ENFORCEMENT CONFIDENTIAL – Not Releasable Under Freedom of Information Act
 Spill Prevention Control and Countermeasures Inspection
COMPLIANCE INSPECTION REPORT
Aloha Petroleum East, Hilo Hawaii
Inspection Date: November 7, 2011
SPCC Case No.: 12-4015

Draft	Final
SPCC Case #	12-4015	Inspection Date	11/7/11	Report Date	2/22/12	Report Version	Final
	Name	Address	City	State	Zip	Check if same as above	
Facility	Aloha Petroleum East	999 Kalanianeʻole Blvd.	Hilo	HI	96720		
Owner Name	Aloha Petroleum	1132 Bishop Street Suite 1700	Honolulu	HI	96813		
Operator Name						X	
Facility Startup		Hours of Operation	8	hrs/day	6	days/wk

Photo No. 1: Tank No. 2, at left, which was overfilled causing the release of Ultra Low Sulfur Diesel to the containment basin, which proved to be extremely pervious.

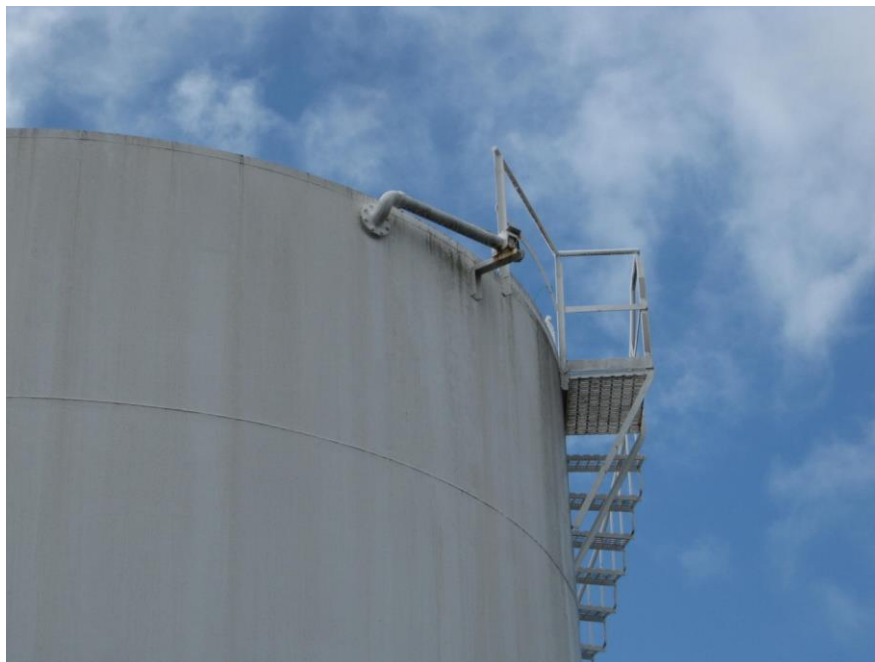
Deficiency Number:	3
Type :	Plan Review and Inspection
Observation:	<p>Based on visual observations made by the inspector during the inspection as well as from details provided by the operator, the secondary containment basin is not sufficiently impervious to contain spill oil. The Ultra Low Sulfur Diesel tank that was overfilled is shown in Photo No. 1. The containment basin where the fuel percolated through the earthen basin material is shown in Photo Nos. 2 and 3.</p>

Requirement:	<p>40 CFR §112.7(c): Provide appropriate containment and/or diversionary structures or equipment to prevent a discharge as described in §112.1(b), except as provided in paragraph (k) of this section for qualified oil-filled operational equipment. <i>The entire containment system, including walls and floor, must be capable of containing oil and must be constructed so that any discharge from a primary containment system, such as a tank, will not escape the containment system before cleanup occurs.</i> In determining the method, design, and capacity for secondary containment, you need only to address the typical failure mode, and the most likely quantity of oil that would be discharged. Secondary containment may be either active or passive in design. At a minimum, you must use one of the following prevention systems or its equivalent:</p> <p>(1) For onshore facilities:</p> <p>(i) Dikes, berms, or retaining walls sufficiently impervious to contain oil; (ii) Curbing or drip pans; (iii) Sumps and collection systems; (iv) Culverting, gutters, or other drainage systems; (v) Weirs, booms, or other barriers; (vi) Spill diversion ponds; (vii) Retention ponds; or (viii) Sorbent materials.</p> <p>And,</p> <p>40 CFR §112.8(c)(2): Construct all bulk storage tank installations so that you provide a secondary means of containment for the entire capacity of the largest single container and sufficient freeboard to contain precipitation. <i>You must ensure that diked areas are sufficiently impervious to contain discharged oil.</i> Dikes, containment curbs, and pits are commonly employed for this purpose. You may also use an alternative system consisting of a drainage trench enclosure that must be arranged so that any discharge will terminate and be safely confined in a facility catchment basin or holding pond.</p>
